EBEY'S LANDING HISTORIC PRESERVATION COMMISSION
ISLAND COUNTY COMMISSIONERS' HEARING ROOM (Room 102B)
1 NE 6th St., COUPEVILLE, WA
AUGUST 28, 2025

Ebey's Landing National Historical Reserve
Certificate of Appropriateness
Connor Tasoff
304 NE Fifth St
COA-25-028

Ebey's Landing National Historical Reserve
Certificate of Appropriateness
Wood
433 Wanamaker Road, Coupeville
EBY-25-023

AFTER-THE-FACT REMODEL; CONDITIONS OF APPROVAL UPDATE

ATTACHMENT A: REVISED SITE PLAN PER HPC CONDITIONS OF APPROVAL

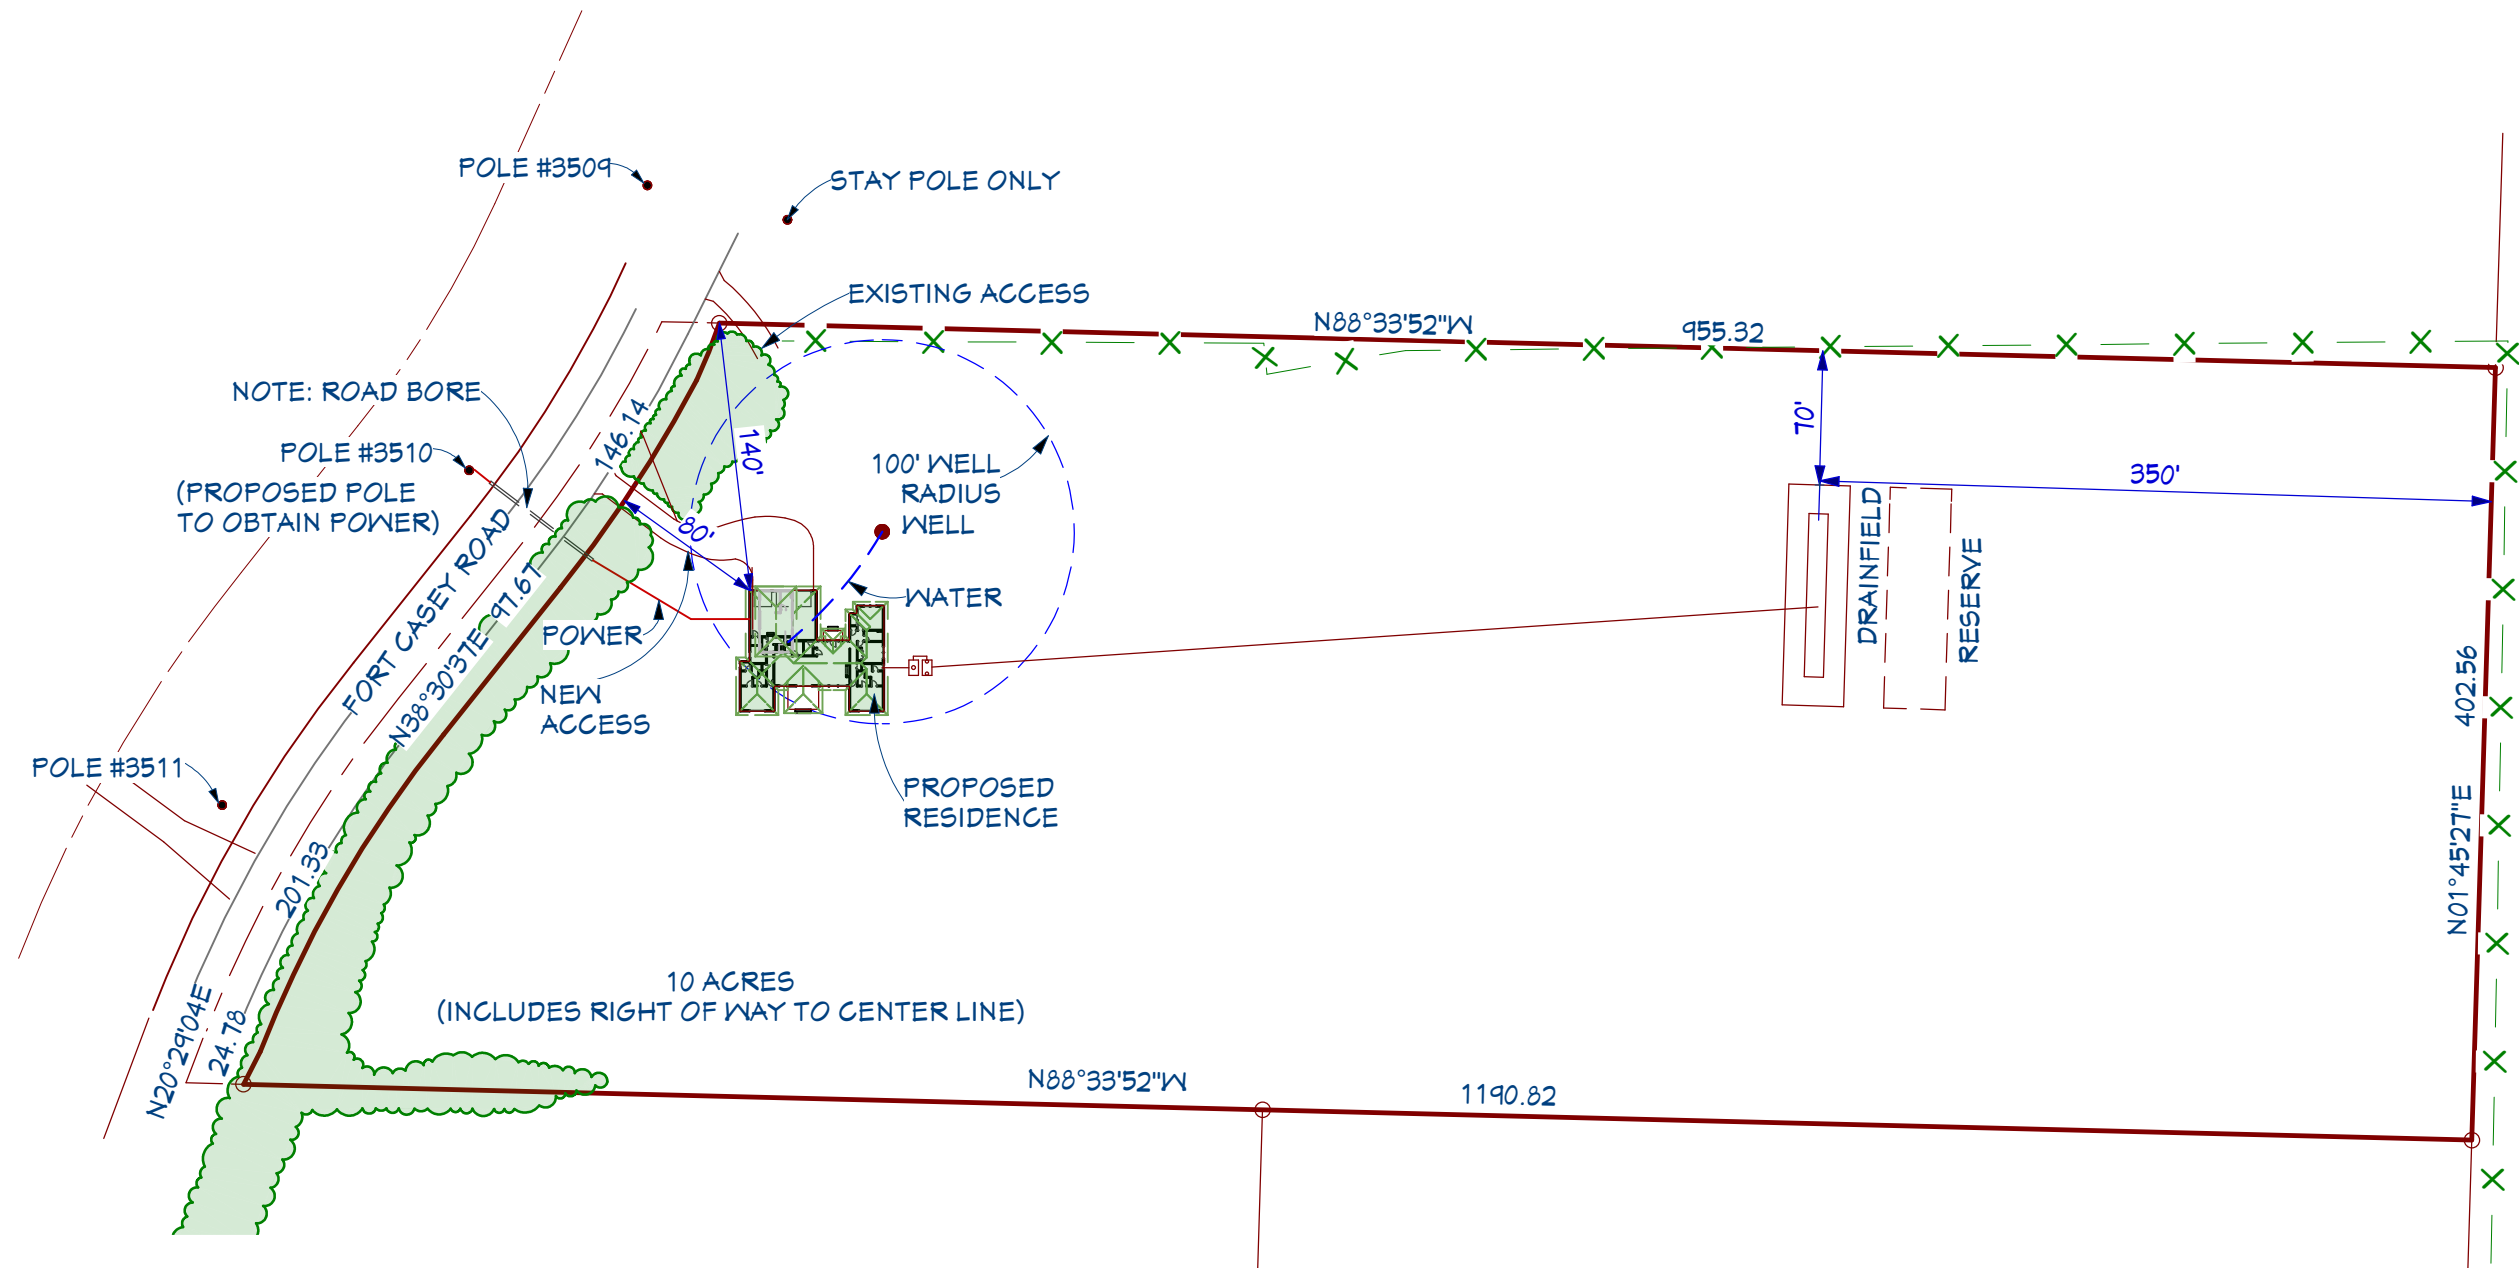
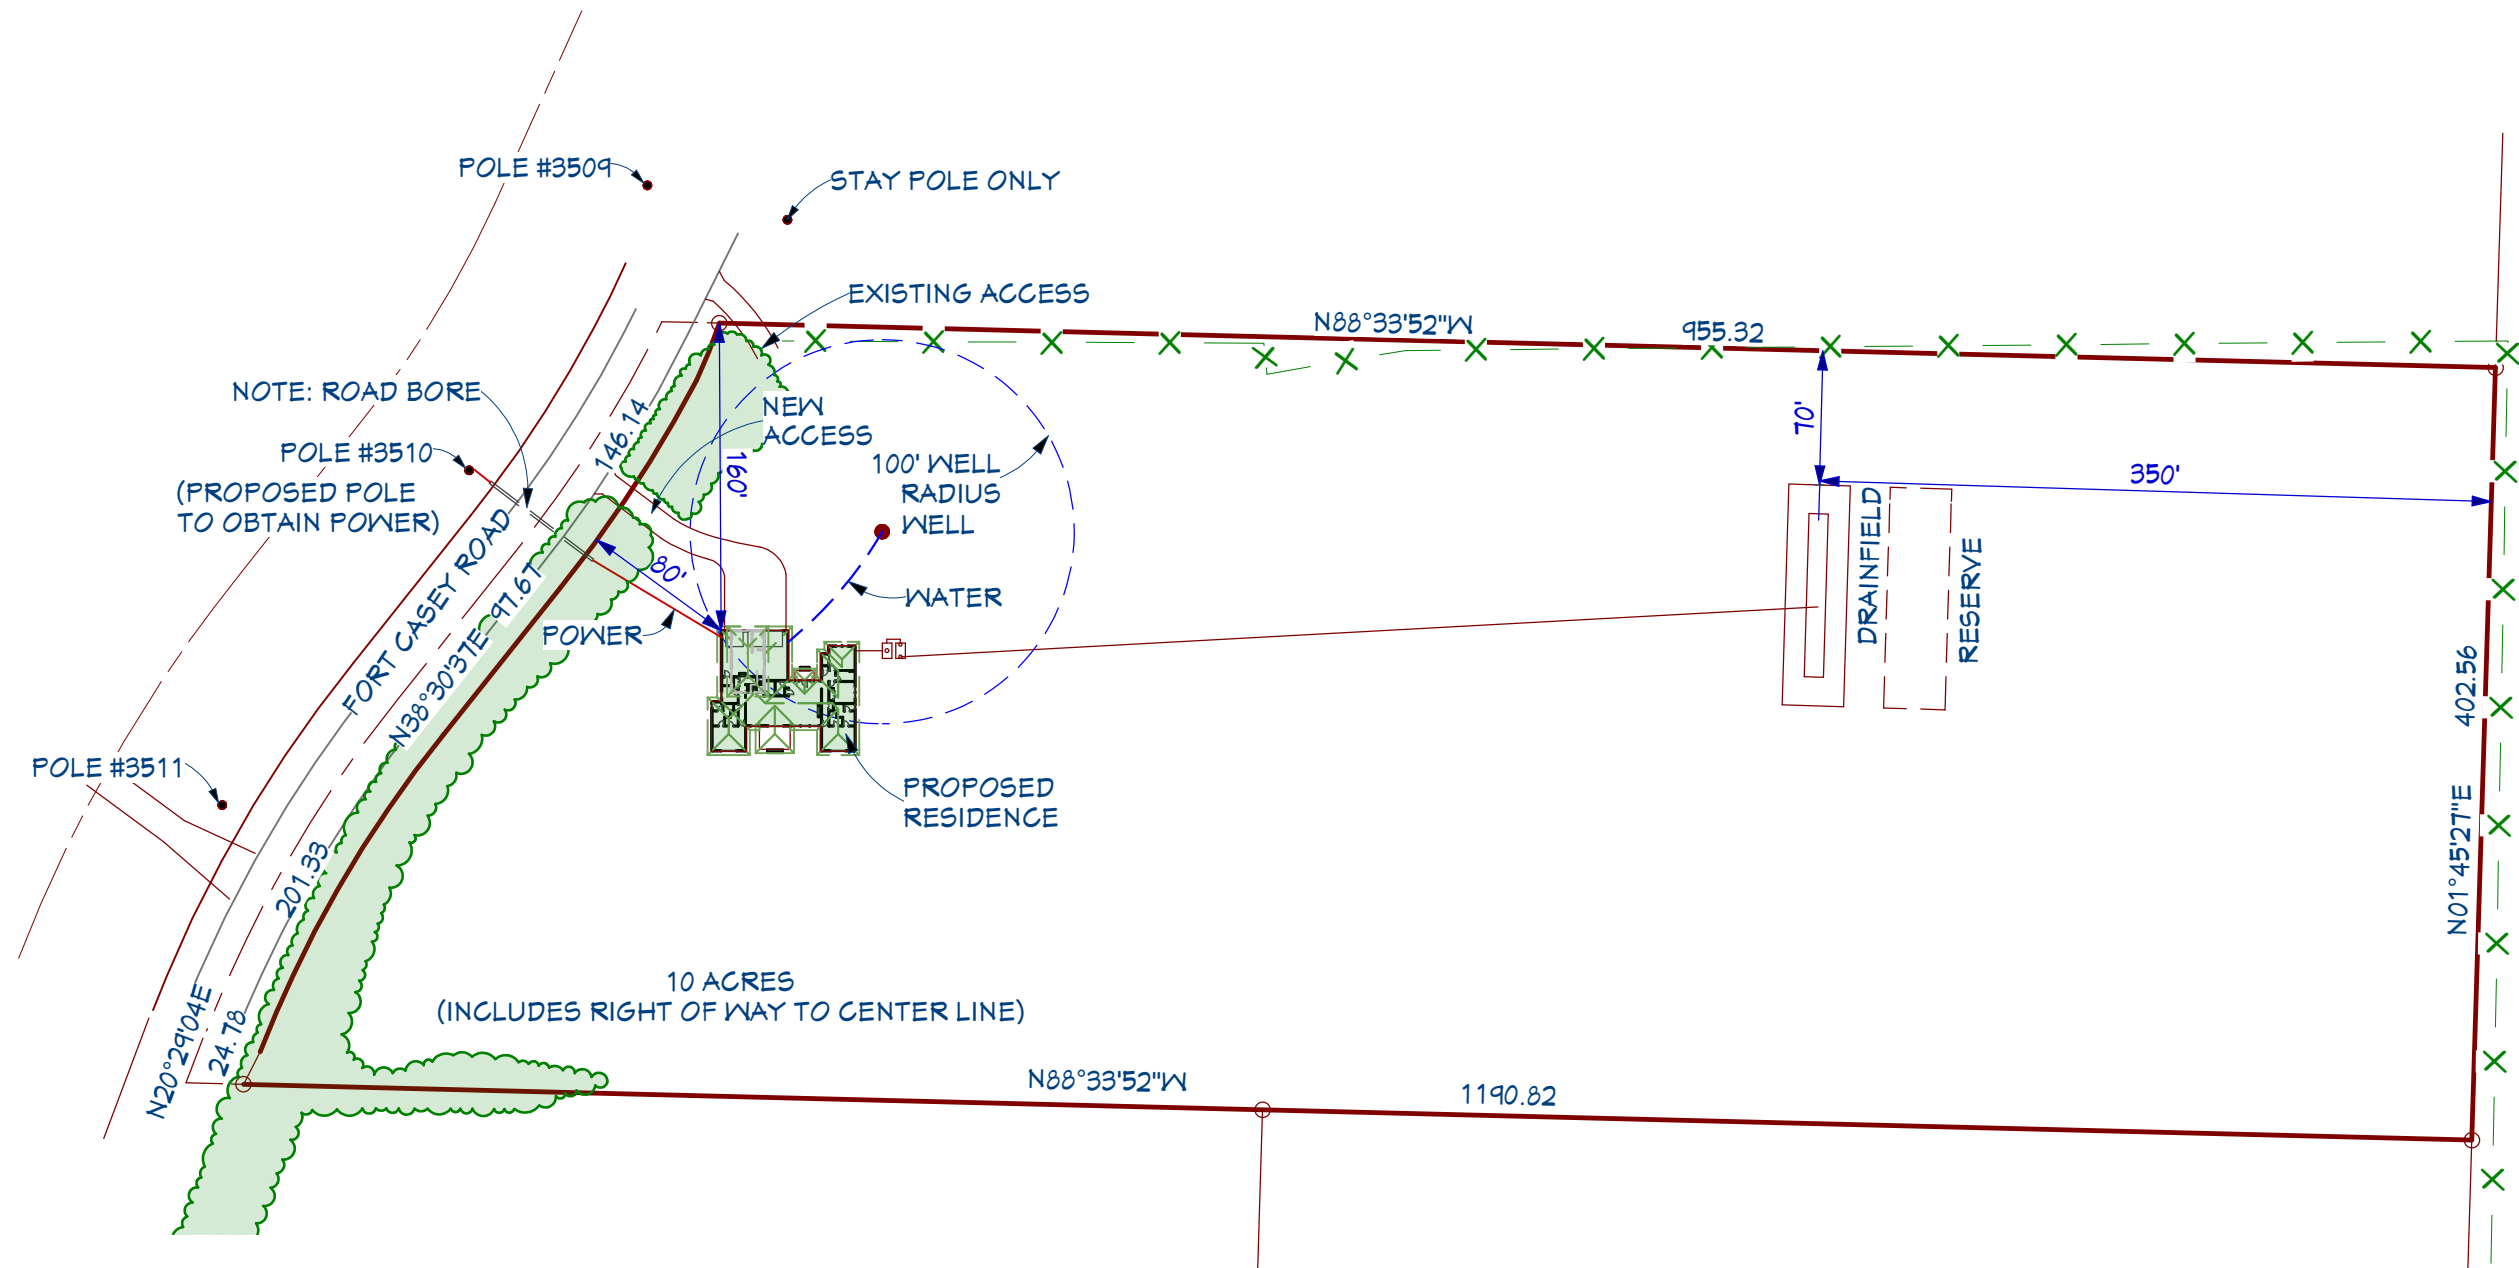
On July 29, 2025, the applicant provided an updated site plan that satisfy the conditions of approval approved by the Historic Preservation Commission.
